MEMORANDUM
MARCH 28TH, 2005

SUBJECT: SAFETY CONCERNS REGARDING THE PROPOSED MIXED OXIDE
FUEL FABRICATION FACILITY (MFFF)
[MOX FACILITY - DOCKET NUMBER: 070-03098]

Safety Concerns and Differing Viewpoints and Opinions on MOX

Alex Murray
Lead Chemical Safety Reviewer
NMSS/FCSS/SPB/MOFLS

CS-01: Red Oil Pressure Vent Relationship

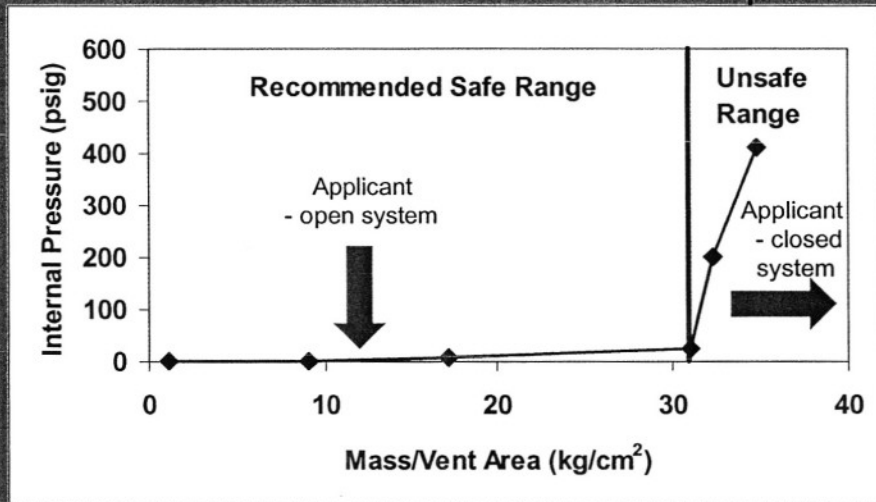
My Conclusions:

- Approach for closed systems does not provide adequate assurances of safety:
 - Corresponds to 1 control parameter (T)
 - Common mode failure – heat transfer and vent
 - Inadequate margin
 - Uncertainties not adequately considered
 - High aspect ratio design will likely result in higher pressures and temperatures, and phase separation
 - No assurance quench system and 125 C limit will prevent red oil reactions
- No assurance approach can meet Part 70 requirements for a Construction Permit

My Recommendation

- Impose DOE/DNFSB RAGAGEP as permit condition
- Give applicant the opportunity to provide assurances about their strategy in the license application

AP-03: Electrolyzer/Titanium Issues – Rapid Heating Possible

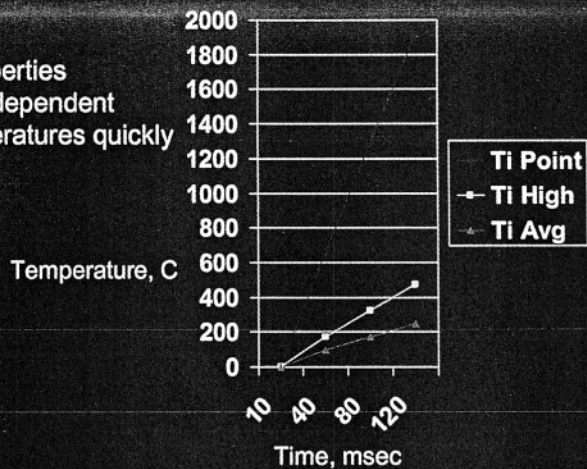
Assumed constant properties
Geometry and system dependent
Potential for high temperatures quickly

N₂O₄ Release Example

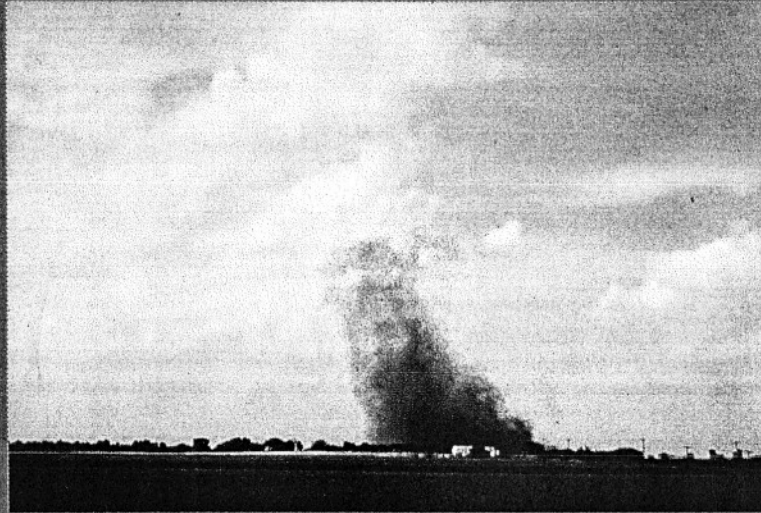
NRC Assessment

- Management/staff
 - 1,500 mg/m³ at 100 meters for N₂O₄ (in EIS)
 - “Immediately lethal”
- My assessment:
 - Estimated concentrations could be higher
 - Facility design exacerbates hazard
 - Safe havens not PSSCs
 - Unlikely operators could reach safe havens or exits

Figure 27 Murphy-Campe / ARCON concentration ratios by wind speed (based upon data from 7 reactor sites in NUREG/CR-6331 on ARCON96)

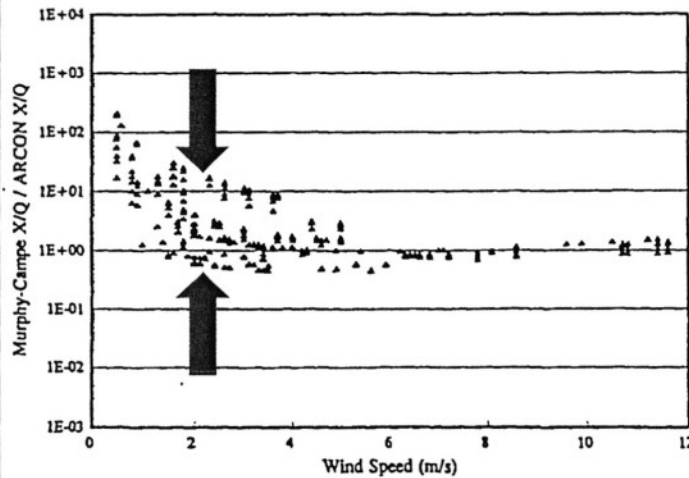
Model/Data Comparisons (I)

• Applicant Using SRS Wind speed Of 2.2 m/sec

• Which value to use?

Figure 28 Murphy-Campe / ARCON concentration ratios by observed concentration (based upon data from 7 reactor sites in NUREG/CR-6331 on ARCON96)

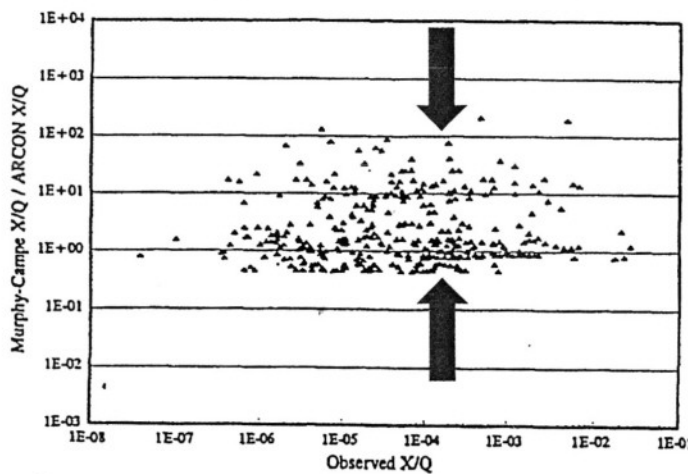
Model/Data Comparisons (II)

Applicant Using Circa 3E-4

Which value to use?
